DRAINAGE CONDITION DISCHARGE

Document Reference. 1-21529-CCL-OS-001

Planning Application No	135936/FO/2023
Site Location	Bignor Street Park Heywood Park Manchester.
Description	Erection of part single, part two storey building to form purpose-built primary school (Class F.1) with associated open space, access, landscaping, boundary treatment and other infrastructure works.
Applicant Name	Department for Education

CCL Response

Site Name	Job Number	Date
Olive School	10/2204	Jan-23
Calculations For	Calcs By	Checked By
SA03	SP	SHP

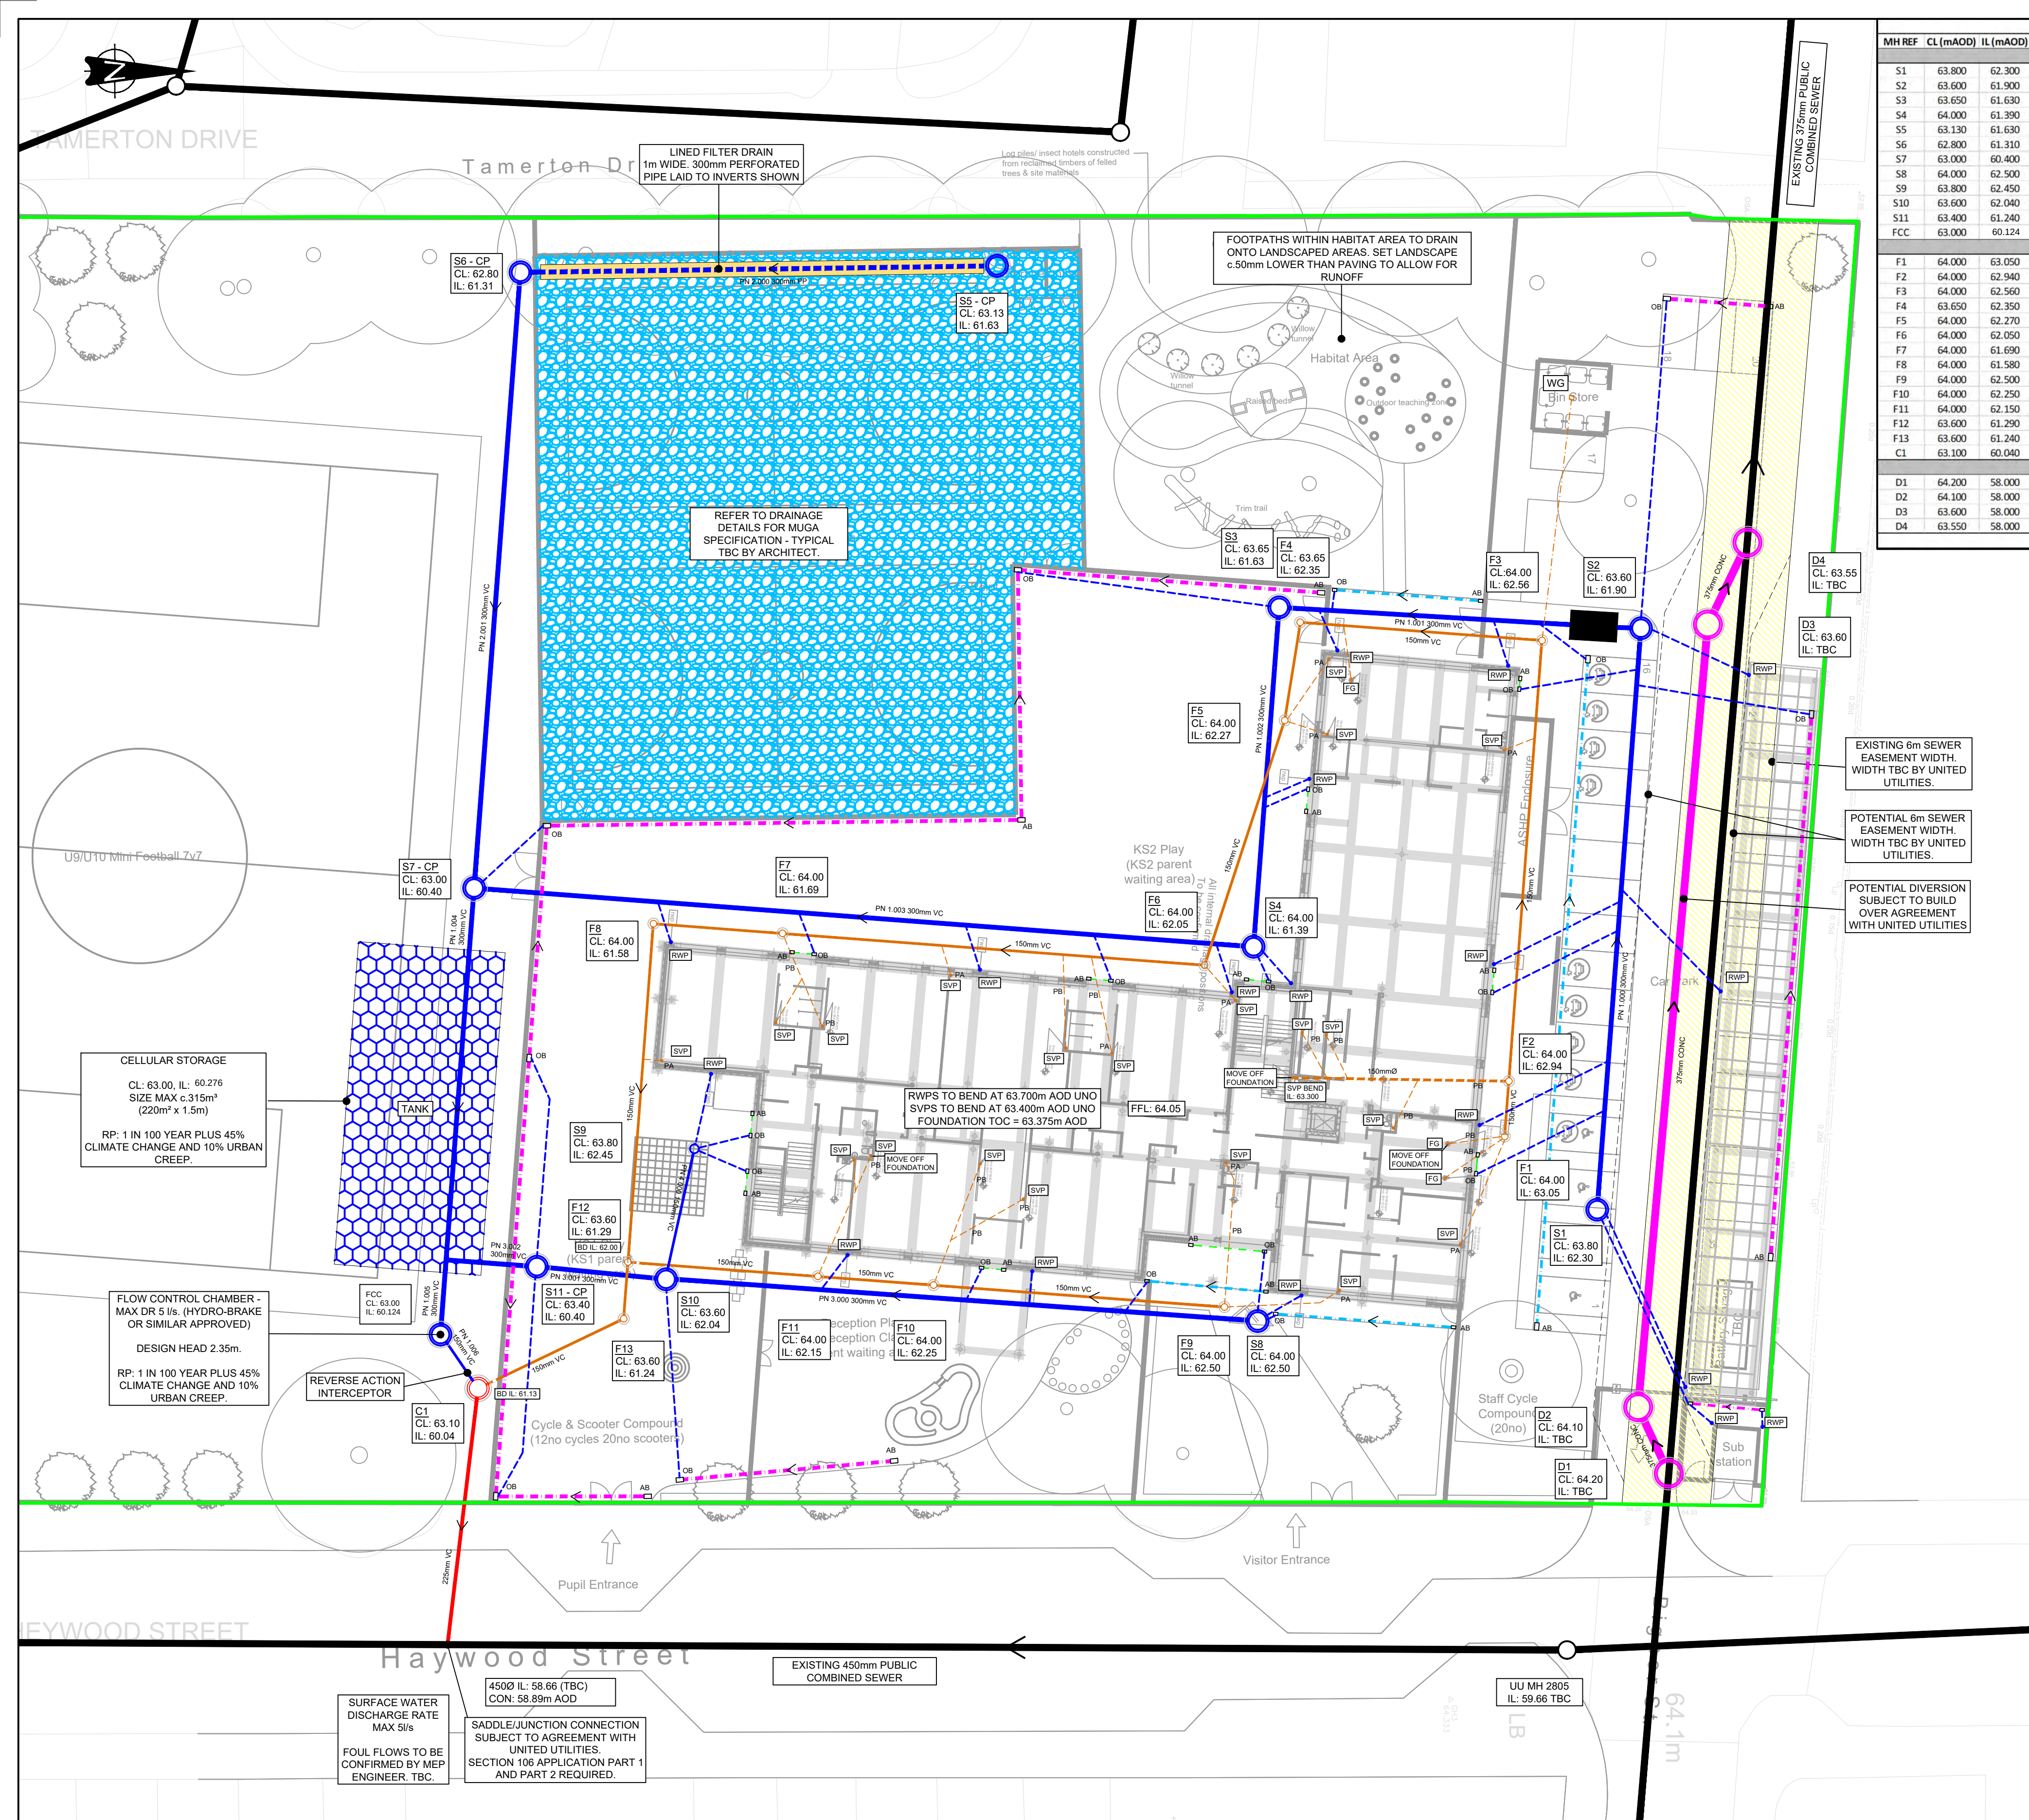
Following our review of the submitted Drainage Strategy, prepared by Clancy Consulting, Ref: 1-21529-CCL-OS-00-RP-0001 Rev B, dated 5.1.23, Although the proposed drainage methodology is acceptable in principle, we have not received further information as mentioned with the report with regards to infiltration testing which would need to be submitted, we also request to see detailed drainage plan with levels information for further assessment prior to planning being granted.

- i. An investigation of the hierarchy of drainage options in the National Planning Practice Guidance (or any subsequent amendment thereof). This investigation shall include evidence of an assessment of ground conditions, the potential for infiltration of surface water in accordance with BRE365.

SA03 (-1.35483E-07m/s)

Based on SA1 (10-6) and SA2 (10-5), both in similar locations to the proposed suitable attenuation tank location, suggest infiltration is potential. Location SA03 suggest infiltration is not feasible.

On this basis, discharging surface water to ground via infiltration has been considered not feasible.
